PREVOST

**WARRANTY
BULLETIN**

Wb03-05

DATE : FEBRUARY 2003	SECTION : 23 - Accessories
EXPIRATION: FEBRUARY 2005	
SUBJECT : APPLICATION OF A PROTECTIVE STRIPE ONTO THE SLIDE-OUT PAINTED LATERAL PANEL

FIGURE 1

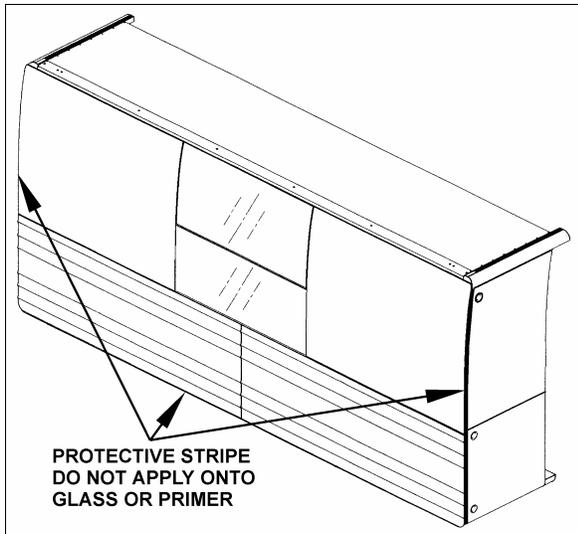
2. Clean out lateral panel surface using degreaser. Use lint free cloth to immediately dry surface off before product evaporation.
3. Unroll vinyl protective stripes, measure and pre-cut the necessary lengths.
4. Remove a length of 4 inches from self-adhesive vinyl tape protective film. Position the protective stripe onto each lateral panel and also underneath slide-out (refer to figures 1, 2 and 3).

FIGURE 2 : UNDERNEATH SLIDE-OUT

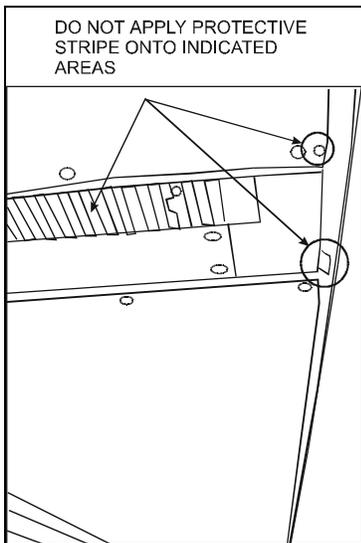
Note: Do not apply vinyl protective stripe to the areas indicated in figure 2. Make sure vinyl stripe is positioned correctly due to the fact that it is difficult to remove once installed.
